GROVE FARM

TRANSPORTATION & HIGHWAY SUPPLEMENTARY REPRESENTATIONS No.2

**HIGHWAYS ENGLAND
DEVELOPMENT CONSENT ORDER APPLICATION (DCO)
FOR
M25, JUNCTION 28 IMPROVEMENT SCHEME**

Redwood Reference: PMcL/3396d3/April 2021

Figure 3.1 – HE preliminary route for Grove Farm egress

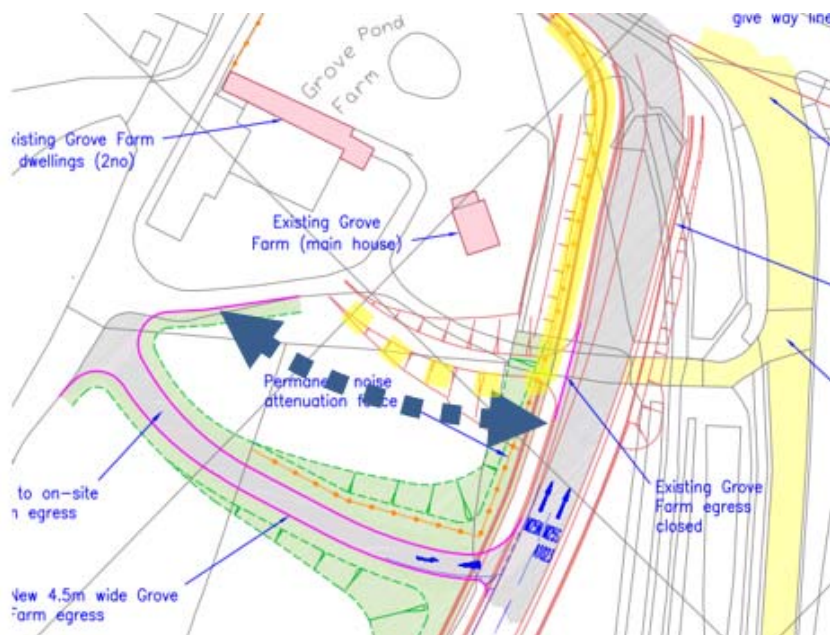
- 3.3 HE has confirmed they are assessing the feasibility of providing an amendment to the alignment of the Grove Farm egress. **Figure 3.1** shows a blue dash of the current potential line of an amended farm egress currently being investigated by HE:

3.4 Grove Farm welcomes this response from HE with regards alteration of the farm egress onto the A12 eastbound off-slip as the relocation of the farm egress will:

- i) Move queuing traffic leaving the site further away from the farmhouses;
- ii) Allow for the inclusion of a reasonably sized landscaped area between the farmhouse;
- iii) Allow for the inclusion of suggested noise attenuation barriers;
- iv) Provide traffic leaving the farm heading south on the M25 with more distance to adequately cross to the right-hand lane when approaching the roundabout.

3.5 It is confirmed by Grove Farm that all Grove Farm land required for a change request for the amended farm egress proposals onto the A12 eastbound off-slip can be made available to HE for the construction of the amended farm egress. Grove Farm request that the distance between the farmhouse and the egress road be maximised.

- i) The closure of the current amended egress from Grove Farm to the A12 eastbound off-slip;
- ii) Construction of a new dedicated egress from Grove Farm to the A12 eastbound off-slip with alteration of on-site roads to suit;
- iii) Provide Grove Farm with a copy of the CAD topographical survey and CAD 3d survey as an internal document;
- iv) Provide proposals at scale 1:1000 [ExA question - PC2.1].

Figure 4.1 – Grove Farm’s suggested location for noise attenuation fencing

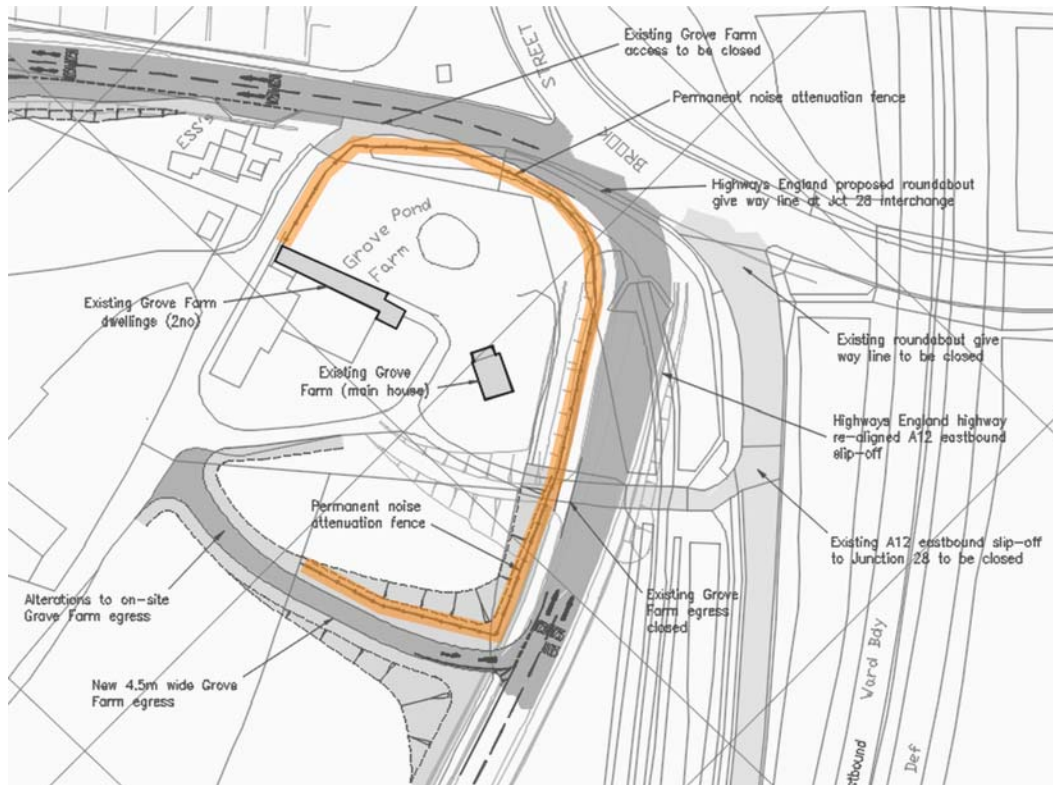
- 4.1 The owners of Grove Farm remain concerned that no permanent noise mitigation measures are included in the HE Scheme surrounding Grove Farm. Our **Drawing No. REDW-3396-115**, previously issued, showed Grove Farm’s suggested location of permanent noise attenuation barriers which would contribute towards the enhancement of Grove Farm’s environment and mitigate increased environmental traffic noise brought about by the HE Scheme. HE proposals for additional landscaping or standard visual fencing will not provide any material benefit for traffic noise reduction [ExA question - PC2.3 (ii)]. HE has dismissed any need for noise attenuation barriers based upon their noise assessment and has not worked with Grove Farm with a view to include a noise attenuation barrier in the HE Scheme; only suggesting visual fencing [ExA question - PC2.4 (ii)].

- 4.2 **Figure 4.1** shows an extract of our **Drawing No. REDW-3396-115** showing Grove Farm’s suggested line for permanent noise attenuation fence (highlighted in orange):

- 4.3 The HE Scheme will not reduce traffic flows and associated future traffic growth on the new and closer A12 eastbound off-slip or the M25 northbound on-slip both next to Grove Farm. The highlighted noise attenuation barrier shows the fence returning into the site at the existing farm entrance and our suggested farm egress. These barrier returns will mitigate against increased noise from traffic flows on the closer A12 eastbound off-slip and the M25 northbound on-slip.

- 4.4 HE's current position on the effect of the HE Scheme on traffic noise is that their noise assessment has established such a significant base level of background noise from the M25 and A12 that the HE Scheme will not produce a material change in traffic noise sufficient to warrant inclusion of physical noise attenuation measures. Mr R Bedson representing Grove Farm at the Hearing referred to his experience in other projects where subsequent post-development noise measurements were greater than the pre-development assessment.

- 4.6 Grove Farm appreciates that HE is constrained in proposing expenditure for noise attenuation where theoretical noise studies show no material effect from development proposals. However, the HE Scheme provides the opportunity to enhance the environment of Grove Farm and partially mitigate the detrimental effects of the HE Scheme on Grove Farm. The provision of a noise attenuation barrier fully supports HE's own goal to enhance the environment for people living and working close to the HE network and not just retain a detrimental status quo.

- 4.7 Grove Farm requests that the ExA require HE to include an appropriate and visually pleasing noise attenuation barrier as environmental mitigation along the coloured line suggested in **Figure 4.1**.
